34401A-15

# SERVICE NOTE

## 34401A Multimeter

10 megohm and 100 megohm ranges drift out of specification

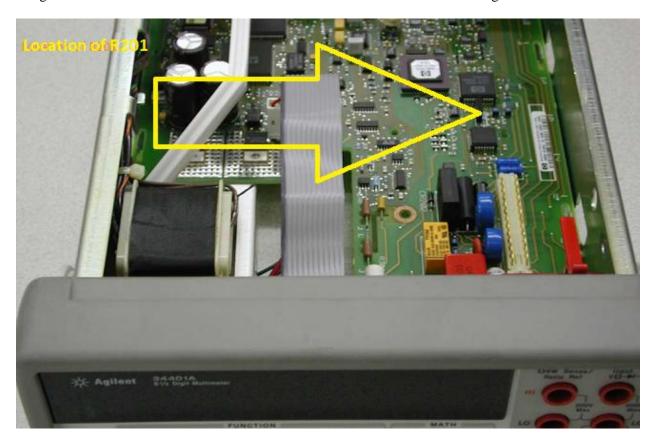
**Customers World-Wide:** Customers with technical ability to replace this resistor may replace the resistor themselves. (Note: A1R201 is a through-hole resistor located between A1U101 and A1U150 on the 34401A main PC assembly.) This approach will provide the minimum instrument downtime and inconvenience.

Locate and remove A1R201. Replace A1R201 and solder into position. Trim leads. Reassemble the 34401A and connect power. Power on the 34401A and allow it to warm up for 4 hours. Perform the Gain Adjustment Procedure found in Chapter 4 of the 34401A Service Manual for the 10 MOhm Range. Perform the Gain Verification Test for the 10 MOhm and 100 MOhm ranges.
